Work Order ID 150303

D3290-3 WINDOW

DRAWING NO. D3290	TITLE REPLACEMENT WINDOW ASSEMBLY	REV. C	DART AEROSPACE LTD ENGINEERING ORDER		D.E.O. NO. D3290-C-1	SHEET NO. SHEET 1 OF 1	SCALE NTS
DRAWN <i>GP</i>	CHECKED <i>JS</i>	MFG. APPR. <i>EZ</i>	APPROVED <i>MD</i>		DE APPR. <i>MD</i>		
DATE 09.09.18	DATE 09.09.18	DATE 09.09.18	DATE 09/09/21		DATE 09/09/21

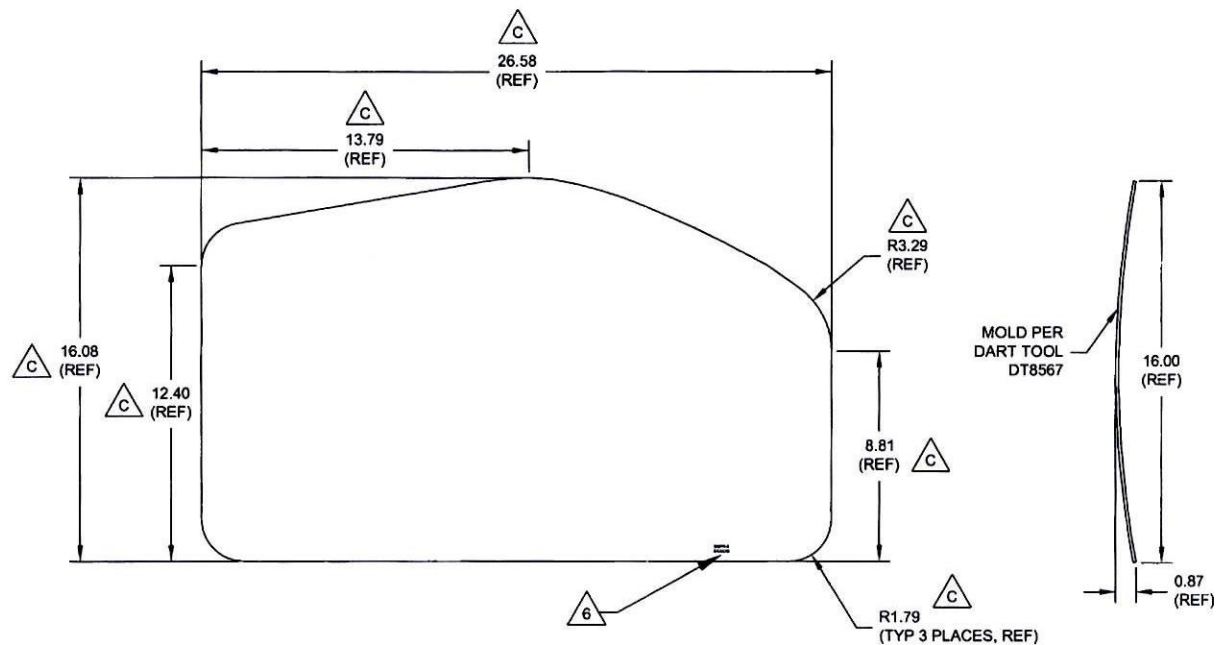
CHANGE MATERIAL THICKNESS OF D3290-1 FRAME TO 0.063 FROM 0.040. REF PAR 09-033.

MATERIAL CALL-OUT OF D3290-1 FRAME ON SHEET 1 IS AMENDED AS FOLLOWS:

- 1) MATERIAL: 6061-T6 (OR 6061-T62) ALUMINUM SHEET ~~0.040 THICK~~ 0.063 THICK (REPLACE)
 PER AMS-QQ-A-250/11 OR AMS 4025 OR AMS 4027
~~(REF. DART SPEC. M6061T6S.040)~~ REF. DART SPEC. M6061T6S.063 (REPLACE)
 OR
 5052-H32 ALUMINUM SHEET ~~0.040 THICK~~ 0.063 THICK (REPLACE)
 PER AMS-QQ-A-250/8 OR AMS 4016
~~(REF. DART SPEC. M5052H32S.040)~~ REF. DART SPEC. M5052H32S.063 (REPLACE)
